PREPARED FOR THE PLAN COMMISSION

**Project Address:** 405-407 & 431 W Gorham Street, 408-430 W Johnson Street, and 304-318 N Broom Street (District 3 – Alder Verveer)

**Application Type:** Demolition Permit, Land Use Restriction Agreement, Zoning Text Amendment, Zoning Map Amendment, Conditional Use, and Certified Survey Map Referral

**Prepared By:** Chris Wells, Planning Division  
Report includes comments from other City agencies, as noted.

**Image 2: The development's four building 'expressions' (masses)**

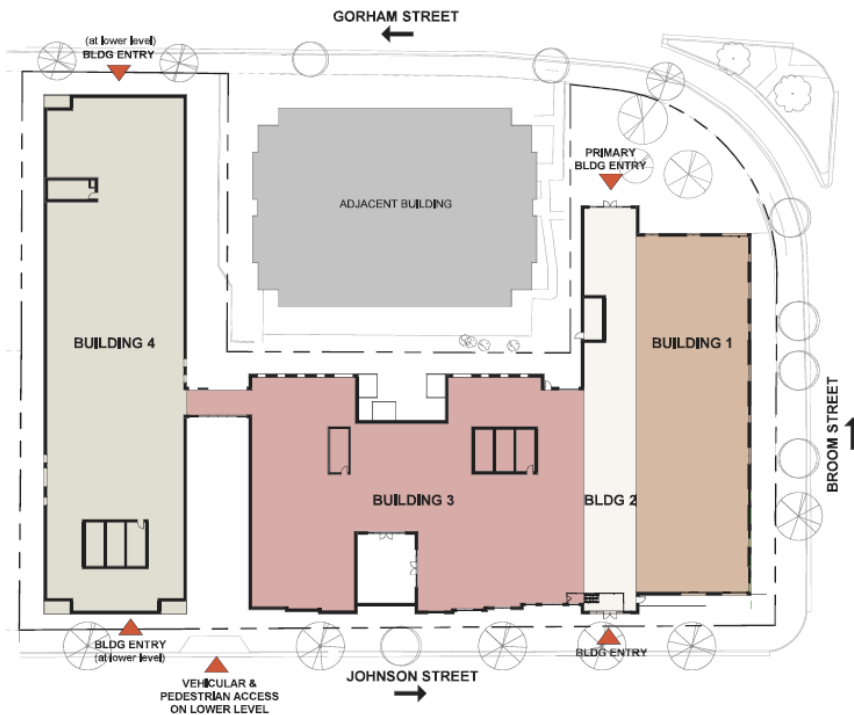
Staff have a few concerns related to the building’s design. The first, which was raised at the Urban Design Commission meeting on November 1, is the lack of ground-floor entrances along the entire 185-foot N Broom Street façade as well as roughly 230 feet of the W Johnson Street frontage. Staff note that the UDC at their aforementioned meeting on November 1, added a condition that an additional connection to the street be incorporated along the W Johnson Street frontage. Staff however still believe that an additional entrance is needed along the N Broom Street frontage noting that, if the Building 1 were a stand-alone building, that a primary entrance oriented to the primary abutting street would be required. (Staff acknowledge that an entrance facing W Gorham could meet this requirement if it were located at or wrapped the north corner).

The second concern is the significant blank wall expanse located on the upper floors of the southwest façade of Building 2 (see Sheet 36 “Elevation Promenade Bldg 3” in the submitted materials). The units on the first eight floors of that façade have multiple windows while the units on Floors 9-14 have none, despite the fact that the upper floors would actually afford a view and be less obscured by the adjacent 12-story Equinox building. When brought up to the applicant, they responded with the following, *“As presented to and approved by UDC, this area on the back side of building 2 is predominately bathrooms on the floors 9-14. This is in the narrow section of the building 2 and the design pushes the living room/kitchen/bedrooms to the Broom- and Gorham-facing facades to maximize views. This section of the building is also effectively screened from view by the Equinox as the building is pulled back from the street frontage and the two buildings are closest together along this property line.”* To this end, Staff note that the northwest façade of Building 2 is set approximately 50 feet further back from W Gorham Street than the same façade of the adjacent 12-story Equinox building meaning the views of the section of blank façade from the public right-of-way will be extremely limited.

**Image 4: Downtown Height Map in MGO Section 28.071(2)(a). Left: the current version (with the area proposed to be changes indicated with a dashed circle). Right: the proposed version with the change made.**

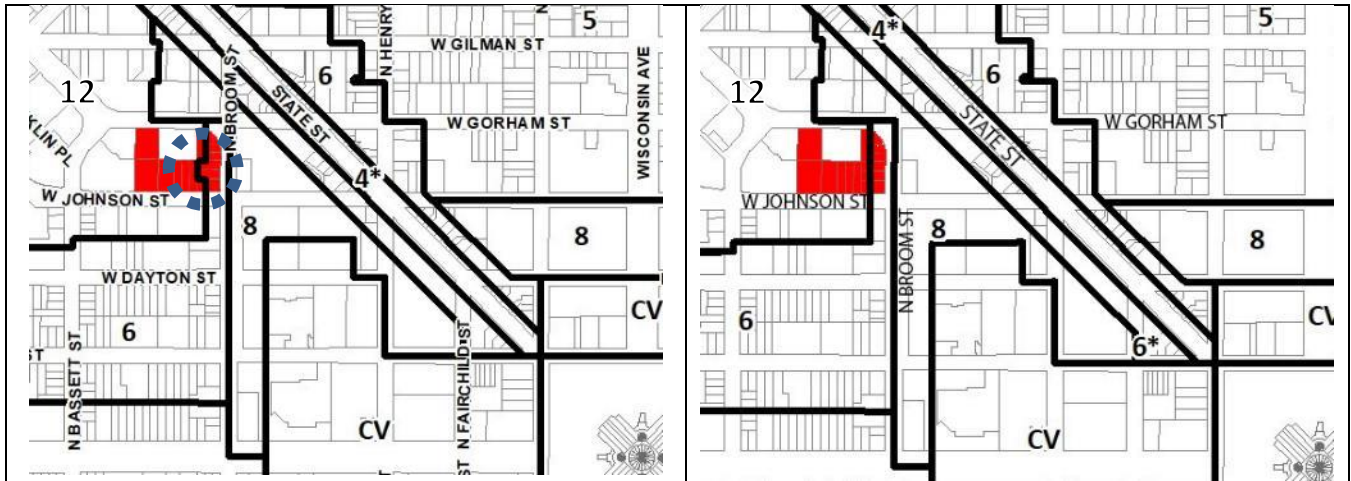
As explained in the previous section, the proposed development exceeds the maximum number of stories allowed by the Zoning Code due to the fact that the City of Madison has granted funding in the form of a below-market value land sale to support the affordable units. That said, Staff believe the 8/15 stories to be consistent with MGO Section 28.071(2)(a)2.a. as the proposed building remains at or below the maximum height in feet in Table 28E-3. (i.e. 88 feet for a six-story building and 172 feet for a 12-story building). With the proposal, the eight-story mass is roughly 85 feet in height and the 15-story masses, even with the rooftop mechanical projections, is roughly 160 feet tall. (Staff note that the buildings, at its tallest, lies just below the Capital Height Projection Limit.)
